PRODUCT CHANGE NOTICE

PCN#22-039

RC-1SPDT-A26
 RC-2SPDT-A26
 RC-4SPDT-A26

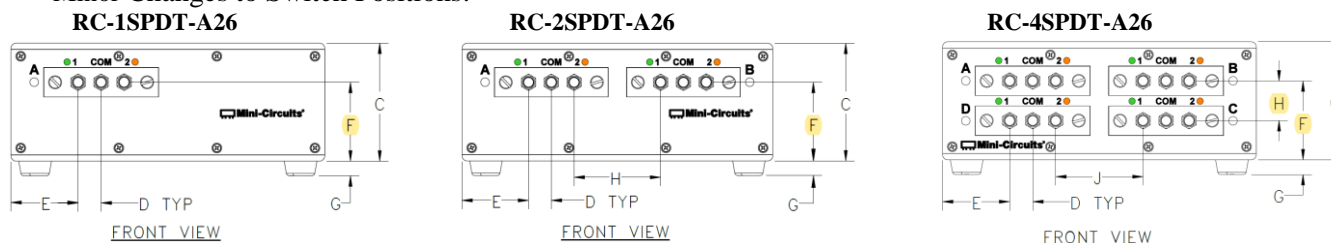
Upgrade of mechanical switch design

- Electrical Specification Changes for both models:

Attribute	Before	After
RF Power (Cold Switching)	Max: 20W	Max: 30W
Switching Time	Typ.: 25ms	Typ.: 15ms
Switch Life	Typ.: 10 million cycles	Typ.: 2 million cycles

- Minor Changes to Switch Positions:

Model	Attribute	Before	After
RC-1SPDT-A26	Dimension F	1.47" (37.3)	1.50" (38.2)
RC-2SPDT-A26	Dimension F	1.47" (37.3)	1.50" (38.2)
RC-4SPDT-A26	Dimension F	1.47" (37.3)	1.50" (38.2)
RC-4SPDT-A26	Dimension H	.688" (17.48)	.757" (19.23)

Improved Switching characteristics, power handling, and allowed more spacing between switches for easier RF cable connections by users.
